UNITED STATES PATENT AND TRADEMARK OFFICE

10/045,986

Office Action Summary

DETAILED ACTION

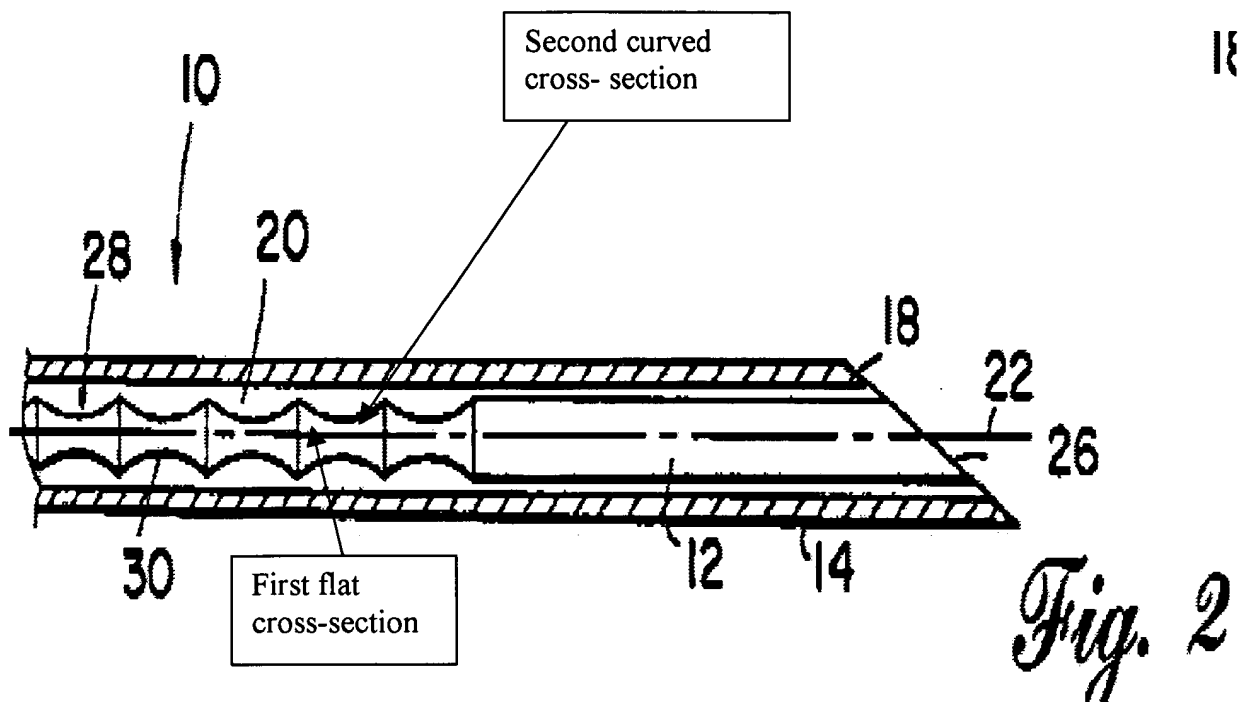
In regard to claims 1, 12, 16, 19, 33, 29, 34, and 39, Davis teaches in Figs. 1-4, a medical device/catheter/needle (10) comprising an elongated body (12); a plurality of concave slot/grooves (28) formed on the distal end (26) of the body (12); wherein a first surface of each concave slots is substantially flat in one cross section or has a bottom surface that follows the contours of the contoured surface and wherein a second surface of each concave slots is substantially curved and wherein the first curved section is perpendicular to the second cross section (please see reproduced Fig. 2below).
